CONDITIONS OF APPROVAL:

Spring Street Subdivision - submittal 001.pdf

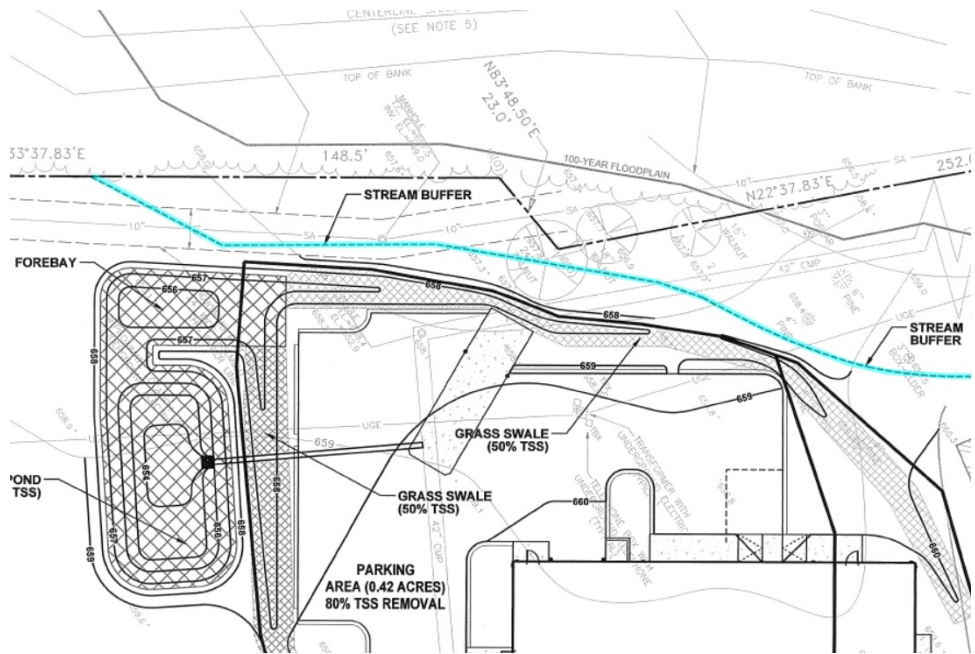
With the stream now being shown and labeled, applicant shall show the riparian buffer for the stream where it falls on the property being platted. This was shown as a "Stream Buffer" on the previous approved site plan (COF #1980, see clipped portion of the plan below with buffer line highlighted):

In addition to Lance's comment provide note:

There shall be no mowing, clearing, grading, construction, storage, or disturbance of vegetation of any kind in riparian buffers except as approved by the City Engineer [Edited By Jeff Willoughby]
